SB Number:	SB 2F8-025	Creation Date: 18/02/2009
Subject:	Improper detection of the empty paper cassette	
Model:	FS-2000D/3900DN/4000DN

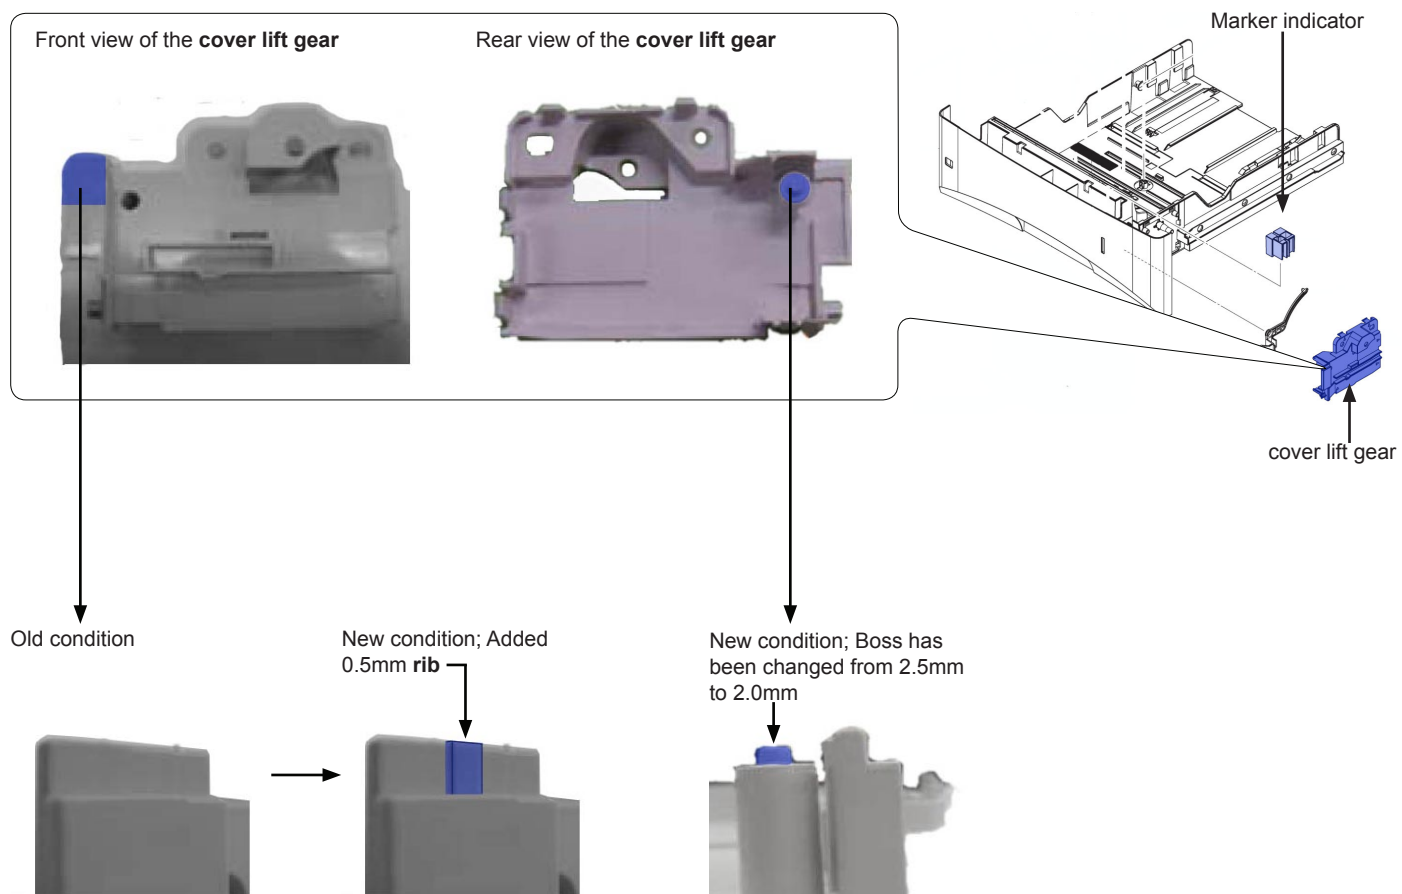
Phenomenon	Improper detection of paper empty.
-------------------	------------------------------------

Cause	Marker indicator 302F909260 does not go down to the bottom of the paper cassette.
--------------	---

Solution	The shape of the cover lift gear has been changed.
-----------------	--

Parts	No.	Old Parts No.	New Parts No.	Description	Q'TY		Interchange-ability		SP
					Old	New	Old	New	
FS-2000D	1	302F809040 2F809040	302F809041 2F809041	+COVER LIFT GEAR	1	1	O	O	-
FS-3900DN/ 4000DN	2	302F909230 2F90923	302F909231 2F909231	+COVER LIFT GEAR	1	1	O	O	-
